Key Adjustments to the South Central Waterfront Combining District and Density Bonus Program

September 10, 2024

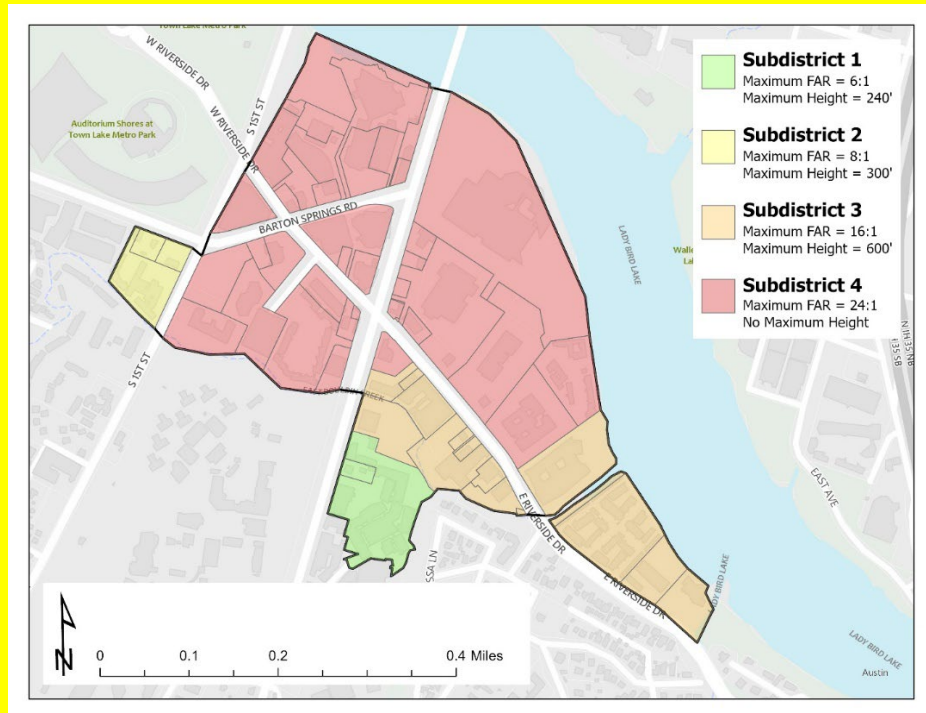
Source	Adjustment
	District boundaries were further expanded to include three properties on the western side of the South Central Waterfront. See the updated map for detail. Section 1.2
 	To underscore the commitment to transit-oriented development in the area, the FAR was adjusted to properties near to the proposed Project Connect station on the north side of East Riverside Drive. See the updated map for detail. Section 3.3.2
	Added Public Access Easements over all Internal Circulation Route options. This was an approved recommendation from Urban Transportation Commission. Section Density Bonus 6.3(C)

Height limits have been added to Subdistricts 1 through 3. They are: 1 - 240', 2 - 300', 3 - 600'. Subdistrict 4 remains with unlimited height. This adjustment reinforces and improves the density gradient from the closest areas to downtown being the most dense, and for the density to transition down as one moves further away from downtown.

Removed Subdistrict 1 (3:1 FAR and 120' max height). Subdistrict map changed per the request of the Planning Commission to match the map below:
